Item Name: Crosstube Turning Detail

DART AEROSPACE LTD	Work Order:	104709
Description: Crosstube Assembly (412 High Aft)	Part Number:	D412-664-243
Inspection Dwg: D412-664-243 Rev: E		Page 1 of 2

DRAWING NO. D412-664-243	TITLE CROSSTUBE ASS'Y (412 HI AFT)	REV. E	DART AEROSPACE LTD ENGINEERING ORDER		D.E.O. NO. D412-664-243-E-2	SHEET NO. SHEET 1 OF 1	SCALE NTS
DRAWN <i>q</i>	CHECKED <i>AS</i>	MFG. APPR. <i>R</i>	APPROVED <i>MP</i>		DE APPR. <i>MP</i>		
DATE 11.09.07	DATE 11.09.19	DATE 11.09.19	DATE 11.09.19		DATE 11.09.19

DRAWING NO. D412-664-243	TITLE CROSSTUBE ASSEMBLY (412 HI AFT)	REV. E	DART AEROSPACE LTD ENGINEERING ORDER		D.E.O. NO. D412-664-243-E-4	SHEET NO. SHEET 1 OF 3	SCALE NTS
DRAWN 97	CHECKED A	MFG. APPR. A	APPROVED MP	DE APPR. MP			
DATE 12.08.21	DATE 12.08.30	DATE 12.08.30	DATE 12/8/30	DATE 12.08.30

D412-664-243
ASSEMBLY DETAIL

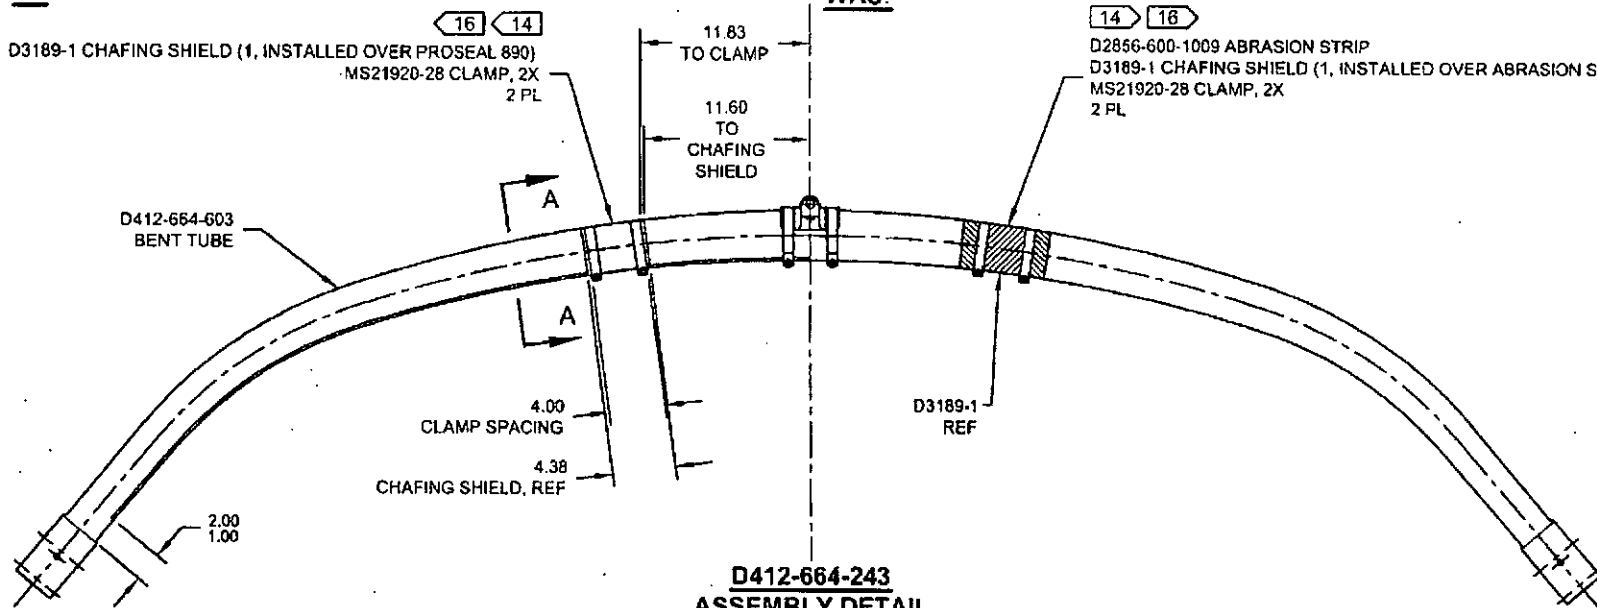
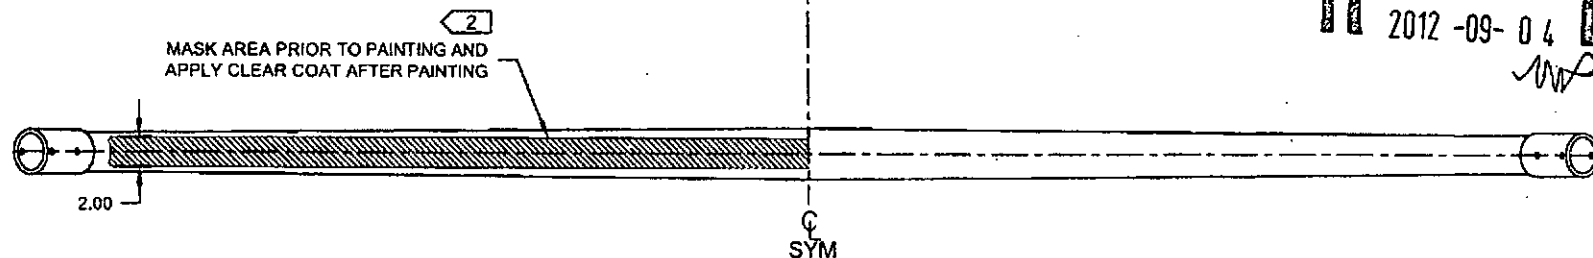
REMOVED ABRASION STRIP IN FAVOR OF A THIN LAYER OF PROSEAL 890. UPDATE INSTALLATION OF CHAFING SHIELDS AND REDUCE TORQUE TO 40-50 IN-LBS. THIS ENGINEERING ORDER SUPERCEDES DEO D412-664-243-E-1.

IS:

D3189-1 CHAFING SHIELD (1, INSTALLED OVER PROSEAL 890)
MS21920-28 CLAMP, 2X
2 PL

WAS:

D2856-600-1009 ABRASION STRIP
D3189-1 CHAFING SHIELD (1, INSTALLED OVER ABRASION STRIP)
MS21920-28 CLAMP, 2X
2 PL

SECTION A-A
CHAFING SHIELD DETAIL
VIEW ROTATED, NOT TO SCALE

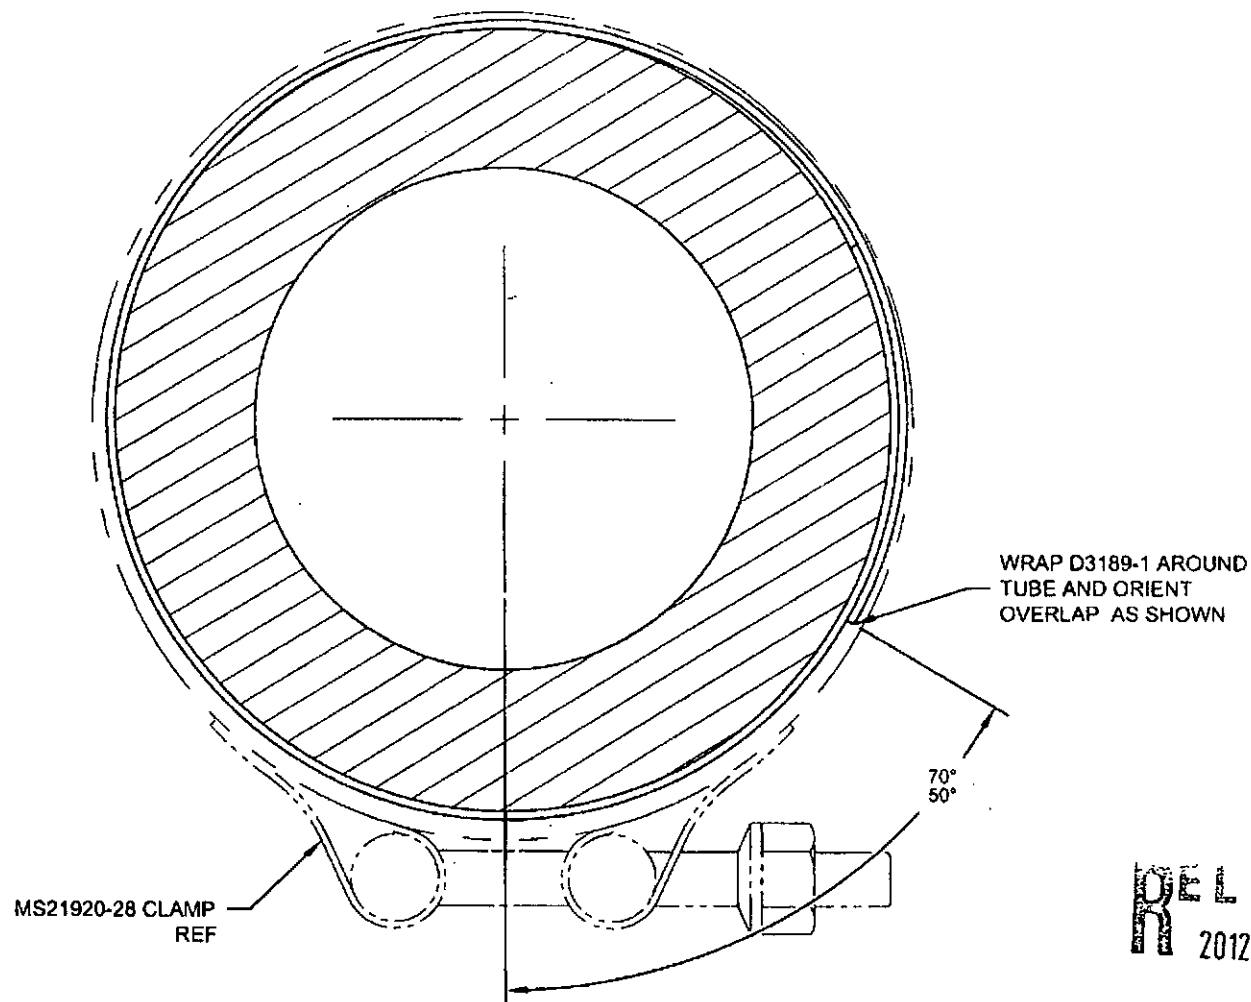
- 2) FINISH: CHEMICAL CONVERSION COAT PER DART QSI 005 4.1
PRIME INSIDE AND OUTSIDE PER DART QSI 005 4.2
MASK UNDERSIDE OF CROSSTUBE AS SHOWN (HATCHED AREA)
PAINT OUTSIDE PER DART QSI 005 4.2
AFTER PAINTING, APPLY CLEAR-COAT ON HATCHED AREA
- 14) APPLY A THIN COAT OF PROSEAL 890 ON INSIDE CONCAVE SURFACE OF D3189-1 CHAFING SHIELD AND LET CURE PER MANUFACTURER'S INSTRUCTIONS. INSTALL PROSEALED D3189-1 CHAFING SHIELD ONTO CROSSTUBE BY APPLYING A THIN COAT OF PROSEAL 890 ONTO CROSSTUBE. BE SURE TO ELIMINATE ANY AIR GAPS.
- 16) TORQUE CLAMPS ON D2896-1 SUPPORT 80 TO 100 IN-LB. TORQUE CLAMPS ON D3189-1 CHAFING SHIELD 40 TO 50 IN-LB. ENSURE AT LEAST 1.5 THREADS SHOWING IN SAFETY AND THAT NUT HAS NOT BOTTOMED-OUT AFTER TORQUING.
